# RETREAT AT TIMBERRIDGE FILING NO. 1

# CONSTRUCTION DRAWINGS

APRIL 2019

**TYPICAL (A) LOT**  
N.T.S.

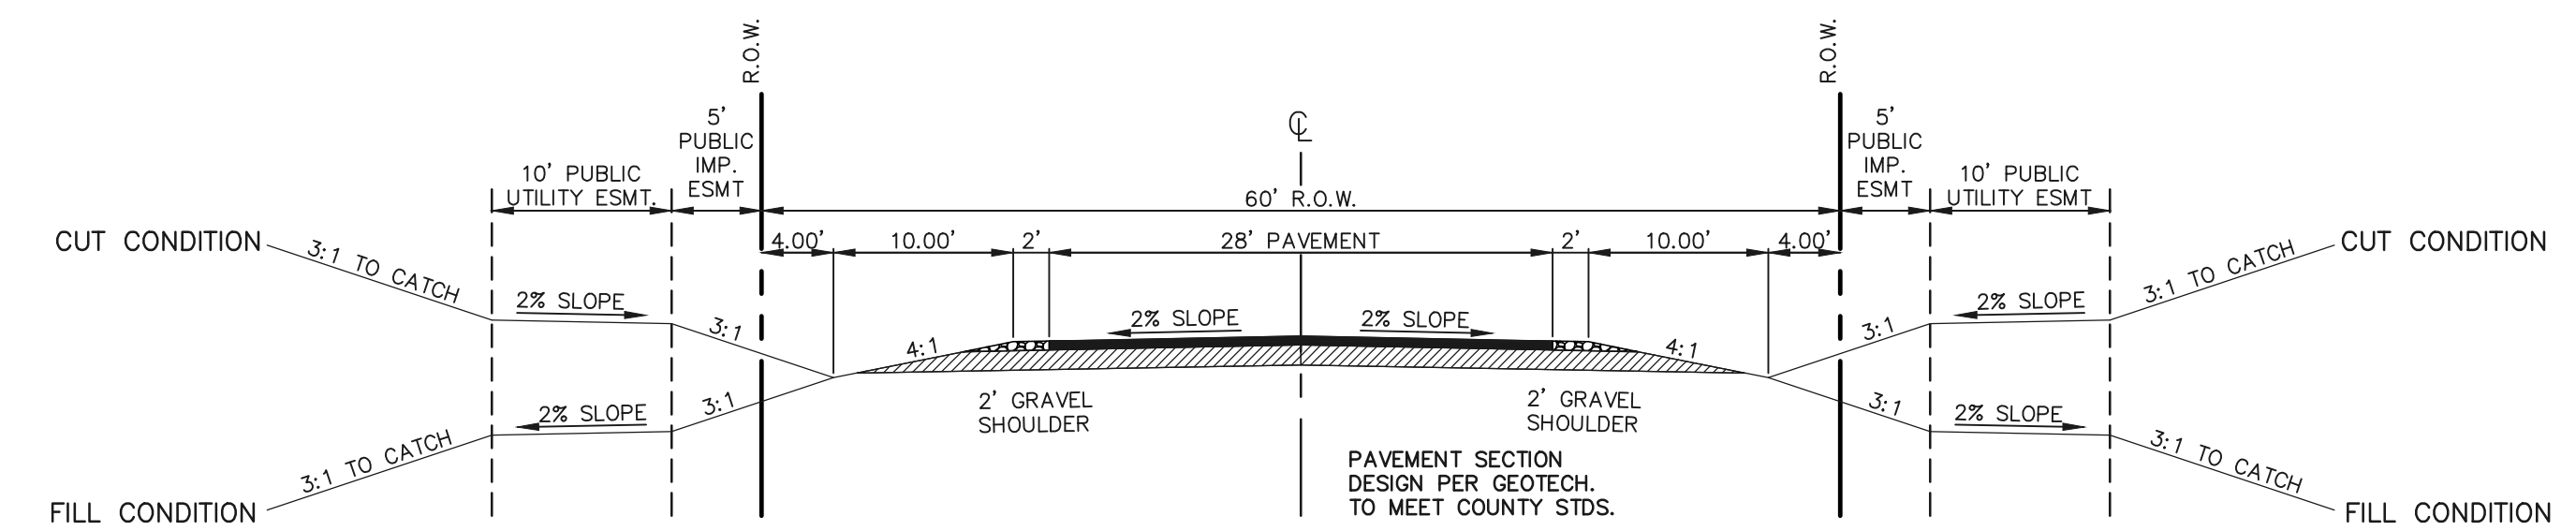
Add a note that side lot swales are required on the downhill lots, either by builder or grading contractor.

RETREAT AT TIMBERIDGE FILING NO. 1  
 CONSTRUCTION PLANS  
 GRADING & EROSION CONTROL PLAN

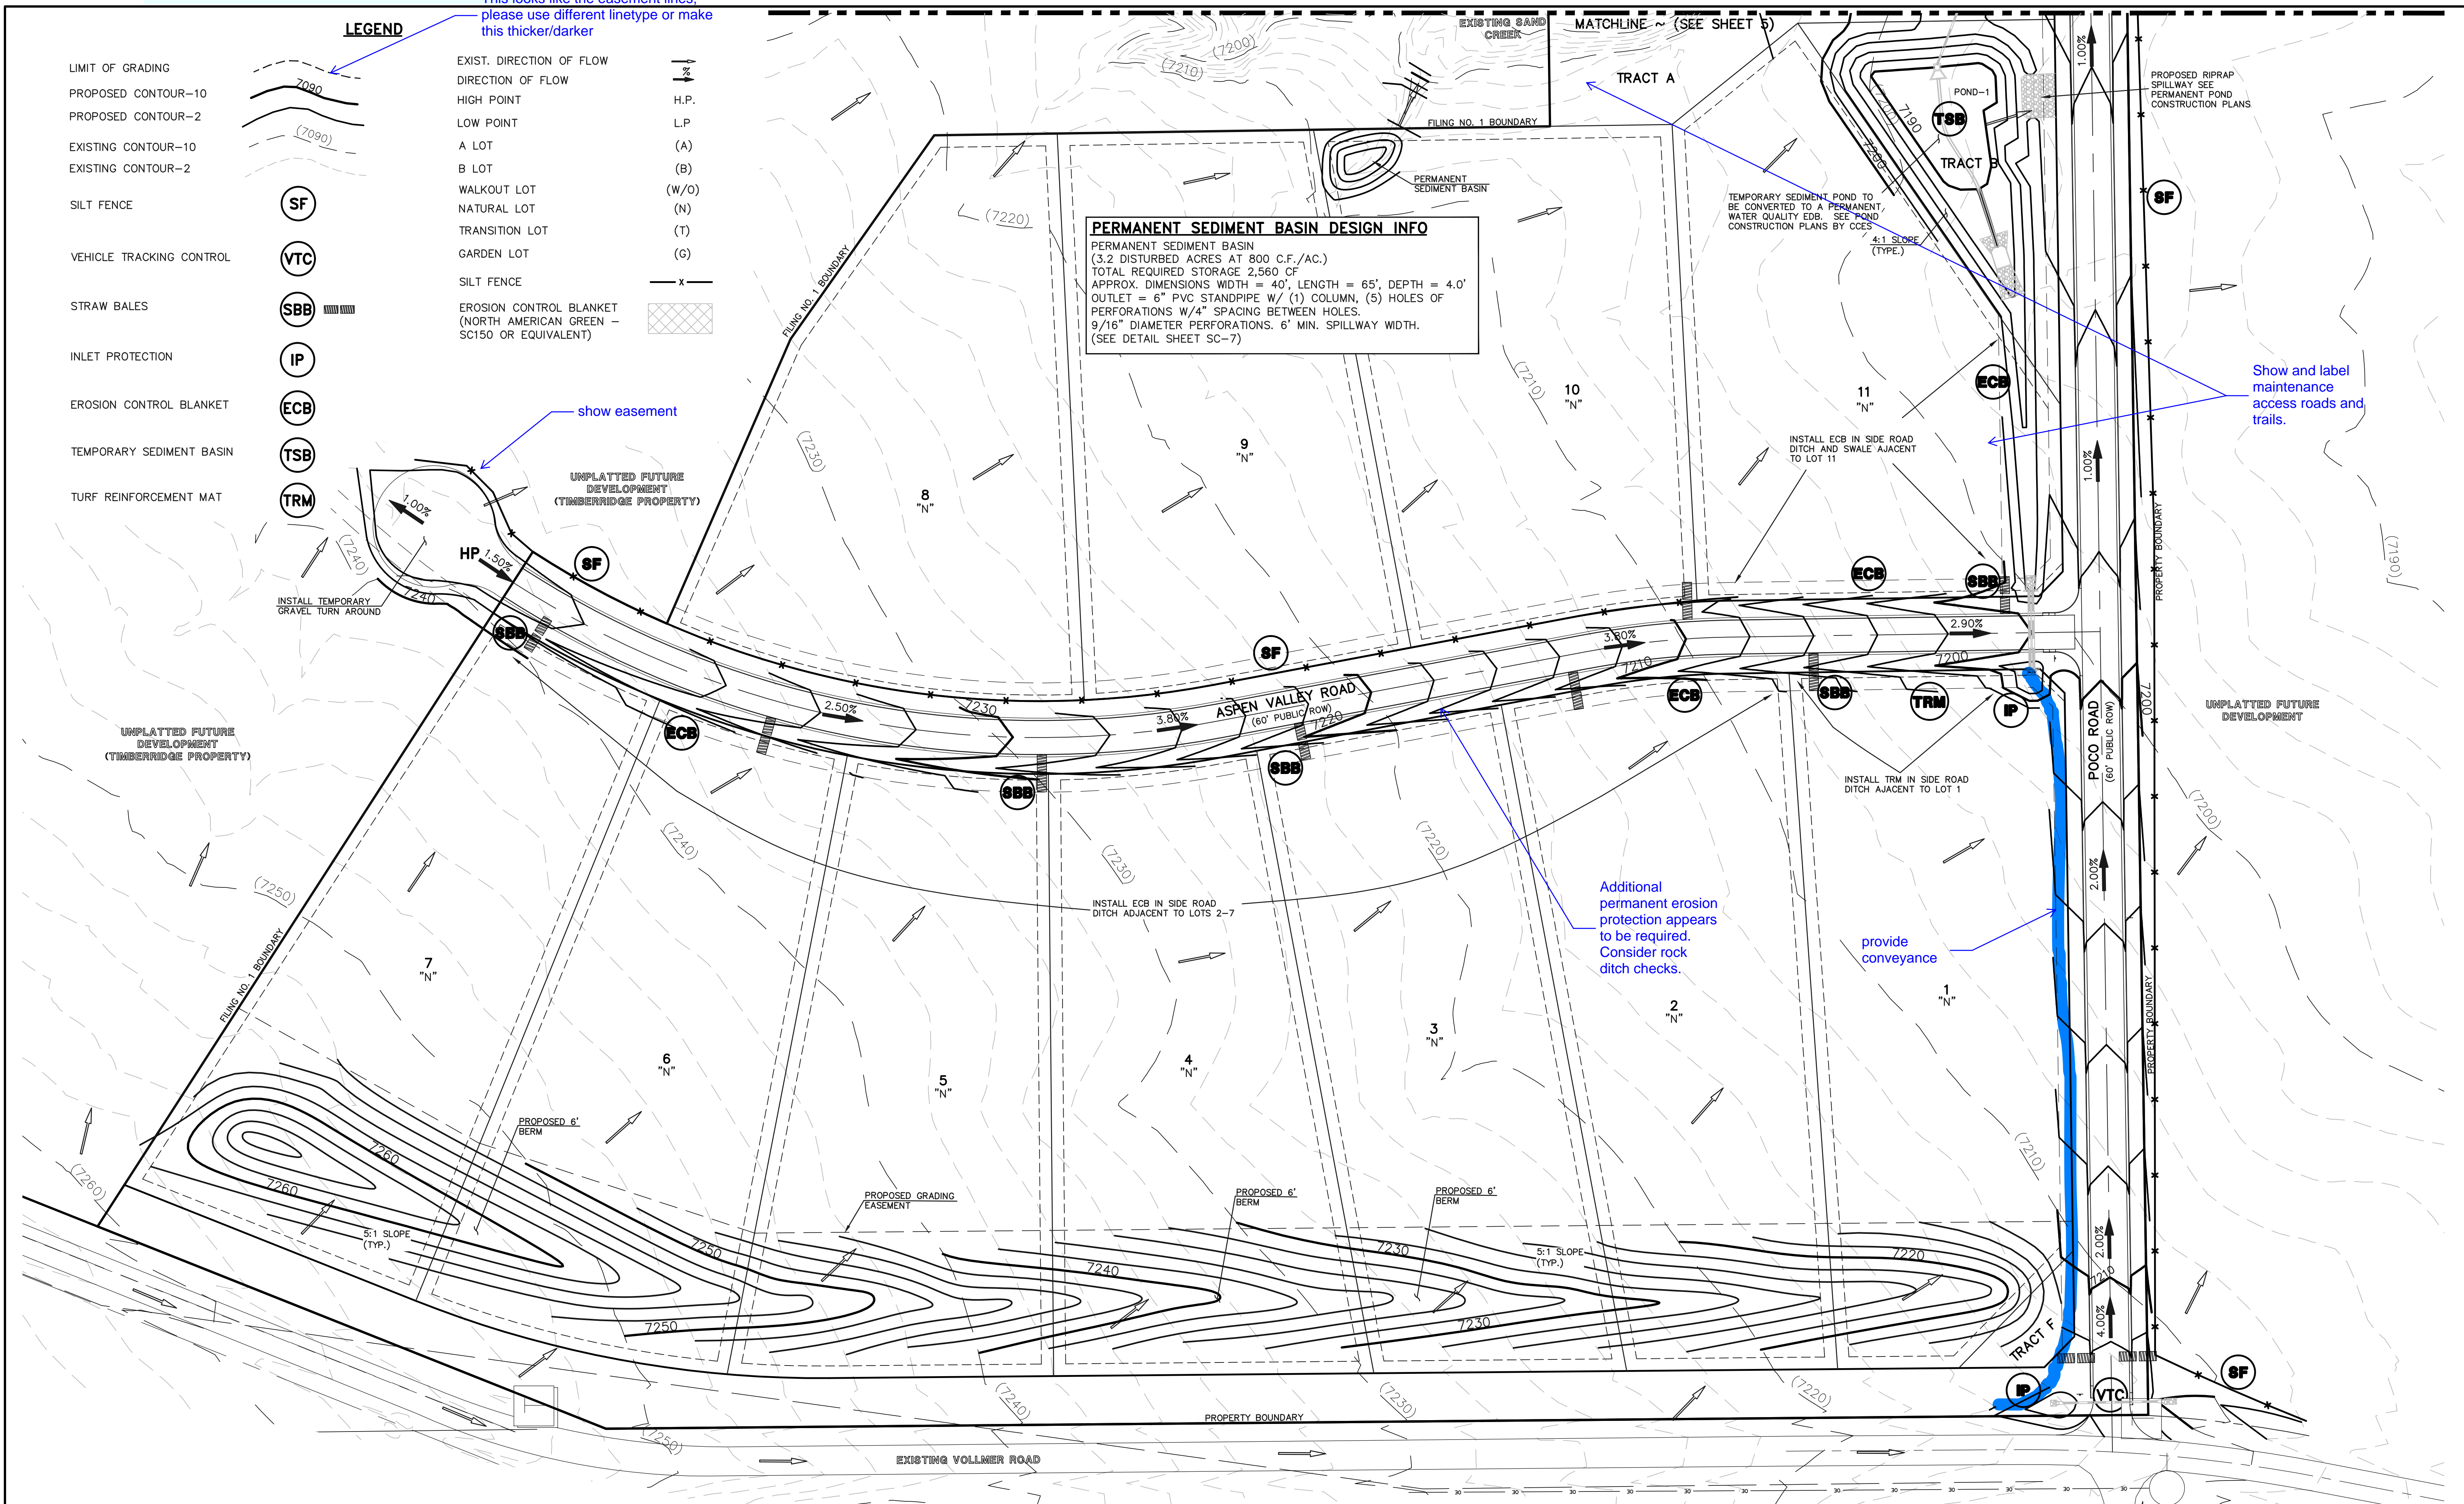
Show and label maintenance access roads and trails.

provide conveyance

RETREAT AT TIMBERIDGE FILING NO. 1  
 CONSTRUCTION PLANS  
 GRADING & EROSION CONTROL PLAN

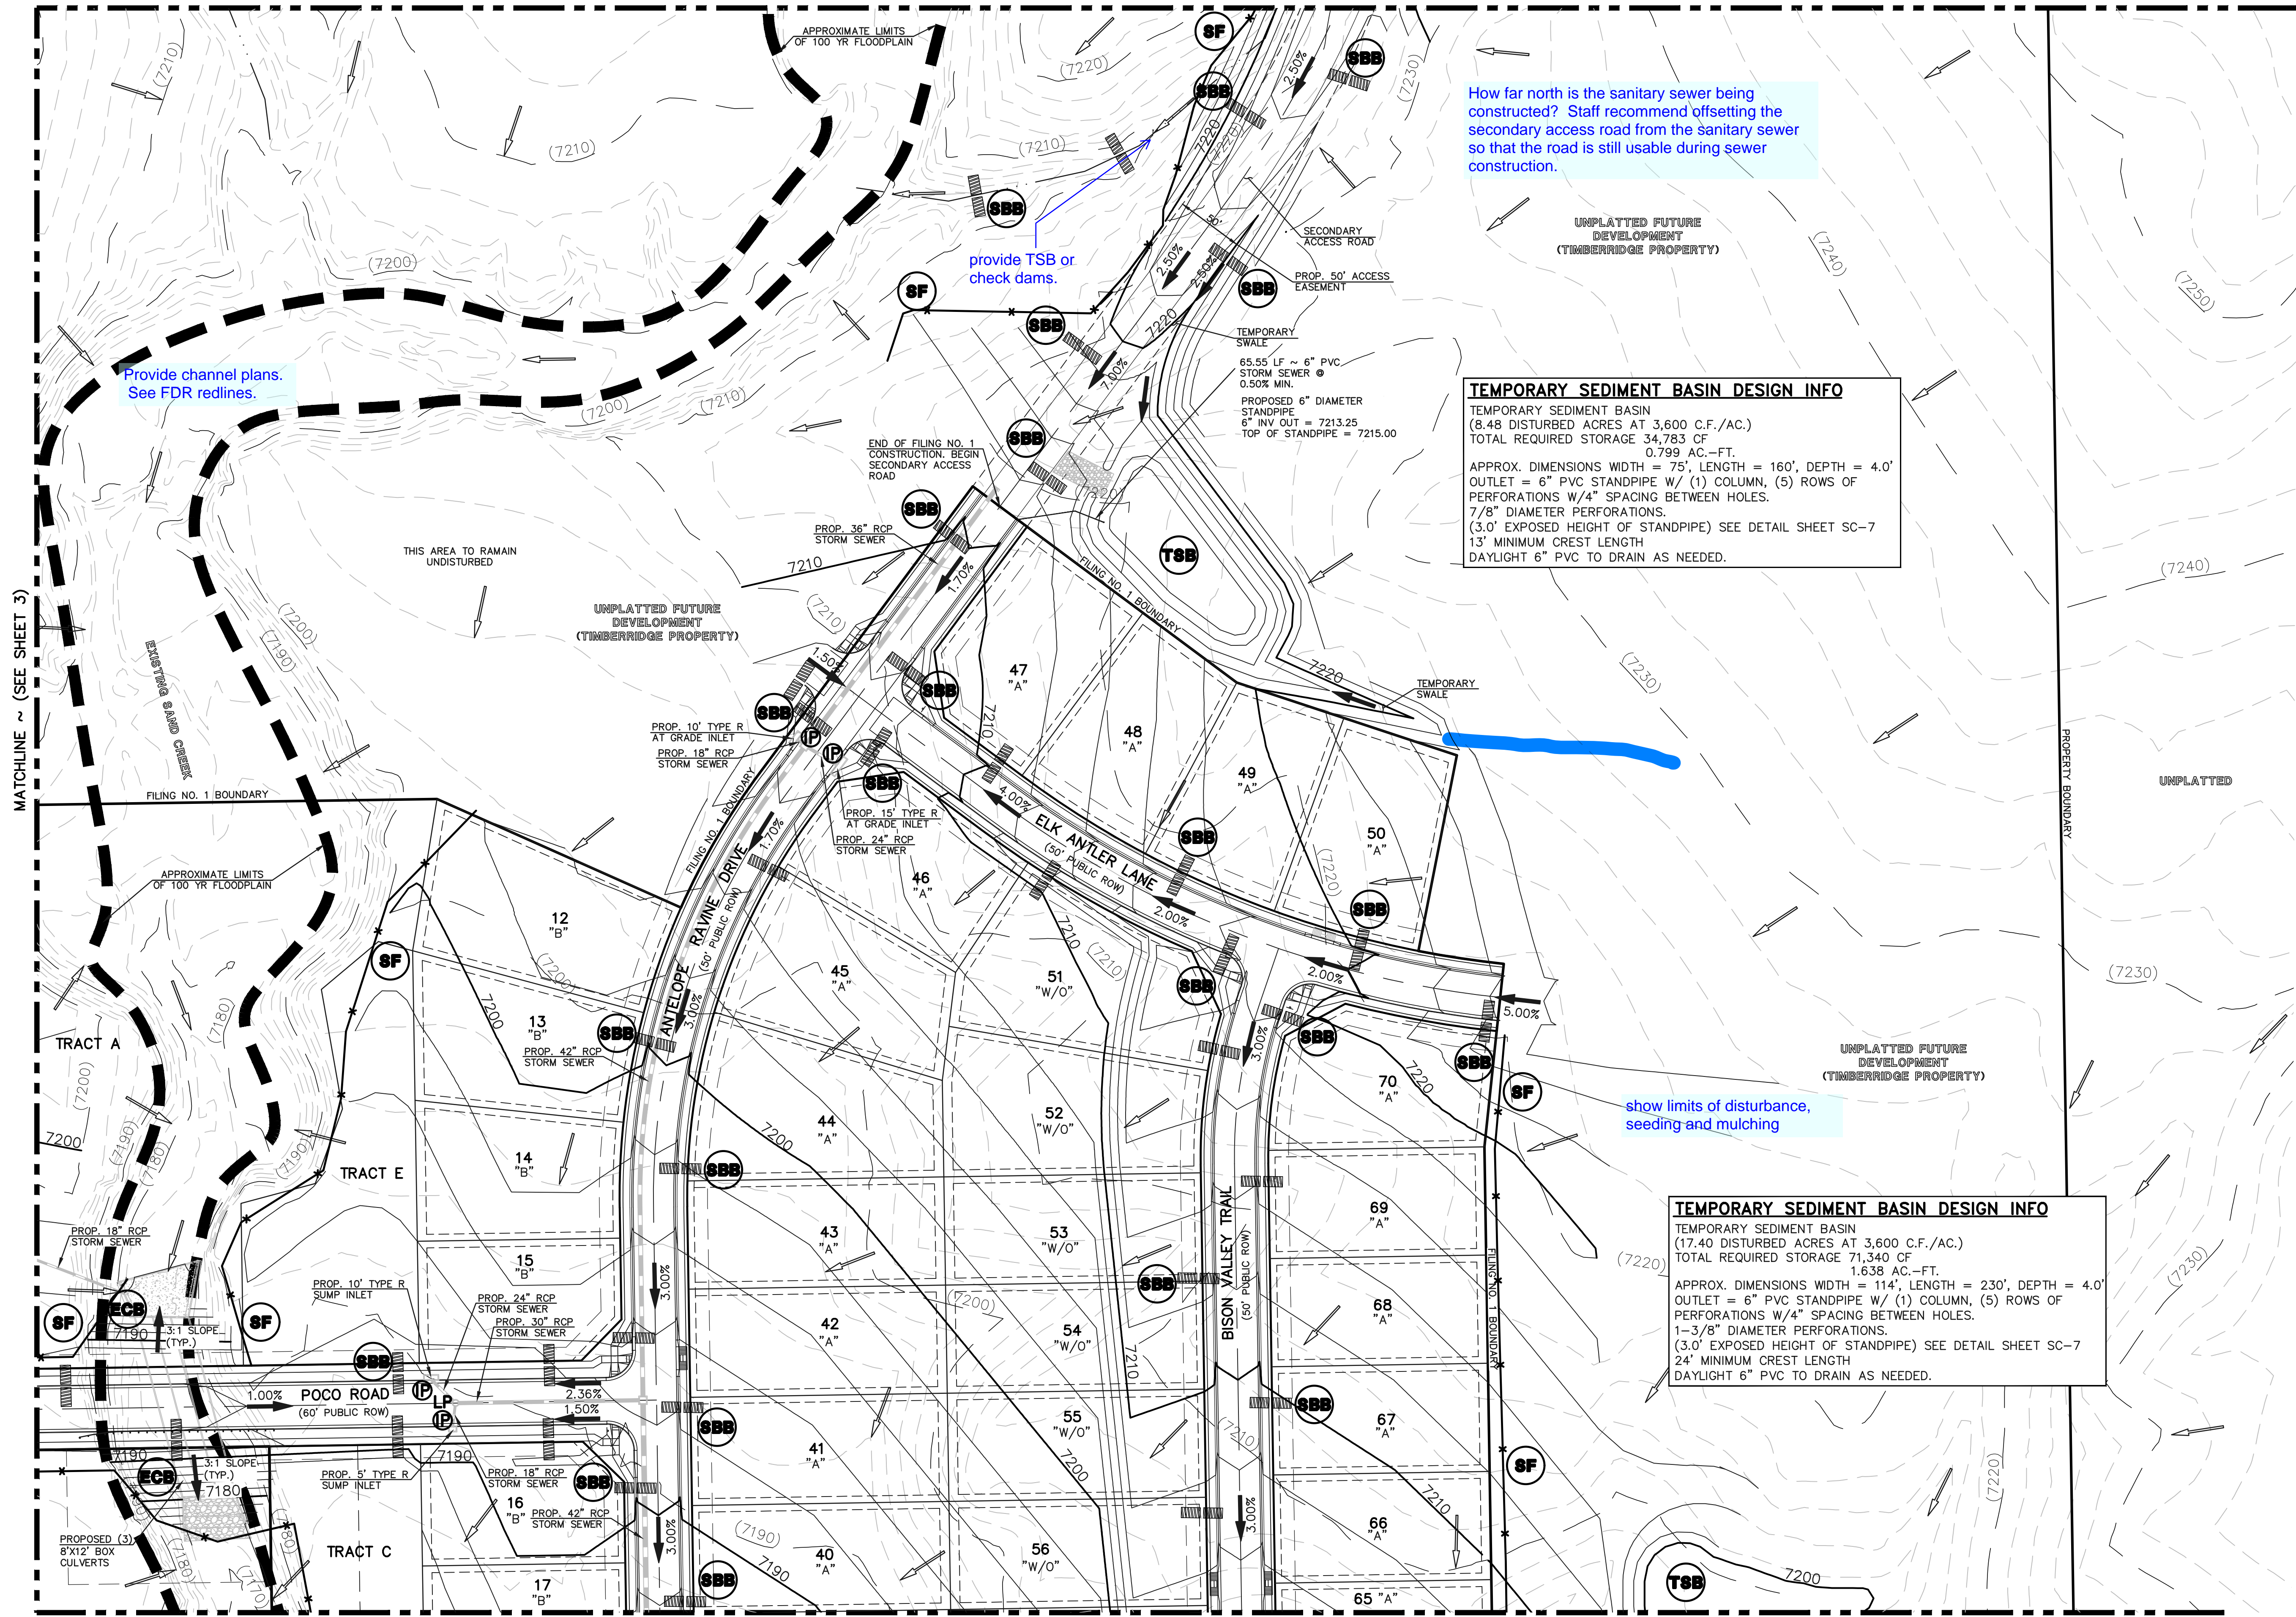
Show spillway protection

Provide spillway erosion protection down the slope.
